Determination 2010/011

Construction of a hot pool building built without boundary fire protection at Arthurs Point, Queenstown

Figure 1: Site plan as proposed

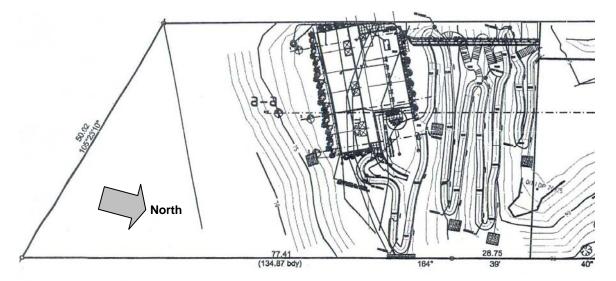
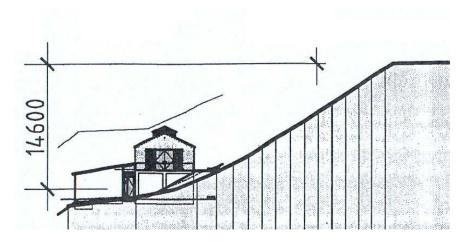
- 7.2 The drawings that have been provided, and which the authority received as part of the building consent process, indicate that the west elevation of the building is extremely close to the boundary. In addition, in its letter to applicant's architect of 9 June 2009, the authority accepted that the complex did not comply with the requirements of C/AS1. However, the authority is of the opinion that, as the fire design was undertaken by a suitably qualified consultant, the officer considering the building consent application had reasonable grounds on which to accept that the design met the requirements of C/AS1. I note also that the authority has since accepted that the owner's application to construct the complex should have been considered in terms of an alternative solution.

Figure 3: "As built" boundary plan showing closest approach of the various wall segments to the boundary

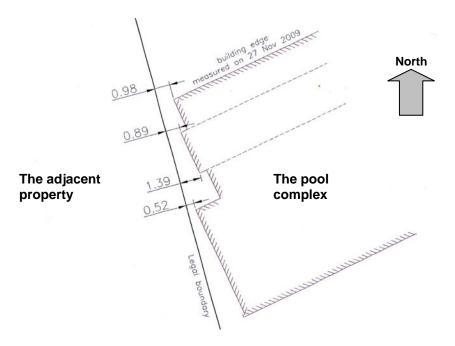
- 7.1 The Fire Report prepared on behalf of the complex owner noted that, as there were no relevant boundaries to consider, there was no requirement to apply an S rating to the complex. The applicant's architect has stated that the west elevation of the complex is a maximum of 280mm from an adjoining common boundary. However, following the issuing of the draft determination, I have now been provided with an accurate "as built" site plan that shows the closest dimensions of the four boundary wall sections as being 520mm, 890mm, 980mm, and 1390mm respectively (refer Figure 3).

- 7.5 To comply with Part 7 of C/AS1, a fully unprotected boundary wall for this complex would require it to be some 9 metres from the boundary. The only calculation method permitted for a wall that is not fully protected, or where part of such a wall less than 1 metre from a relevant boundary and having an intersection angle of less than 80 degrees, is Method 1. Figure 7.4 of C/AS1 indicates the permitted size of the unprotected areas and fire-resistant glazing requirements to comply with the Acceptable Solution. I have not received any information that establishes that the west elevation of the complex as shown on plan L-09 has the required fire-resistant glazing or fire-rating of the external timber-framed walls to satisfy that requirement. Accordingly, I must consider the fire design of the complex in terms of an alternative solution.

- 7.6 In this respect I am not aware of any compensating factors that offset the lack of fireresistant glazing or fire-rating of the west elevation of the complex. In addition, I note that the Fire Report indicates that no S rating provisions have been incorporated within the complex. In my opinion, due to the proximity of the complex to a common boundary, this is a further omission that should be rectified.

- 7.12 The options available to the owner to rectify the matter include:
 - application for a waiver under section 67 of the Act of particular provisions within Clauses C3 and C4 relating to the external spread of fire
 - the completion of additional building work required to achieve compliance with Clauses C3 and C4
 - reclassification of the building consent for a limited intended life under section 113 of the Act conditional on the development of the neighbouring site.

8.1 Based on my decision, the authority should withdraw the code compliance certificate that it has issued for the complex. A notice to fix should then be issued requiring the complex to be brought into compliance with the Building Code. It is then for the owner of the complex to satisfy the authority how code compliance is to be achieved as an amendment to the original consent. Once the authority is satisfied on reasonable grounds that the remedial work ensures that the complex is code compliant, then it should amend the original building consent and issue a new code compliance certificate based upon that amendment.
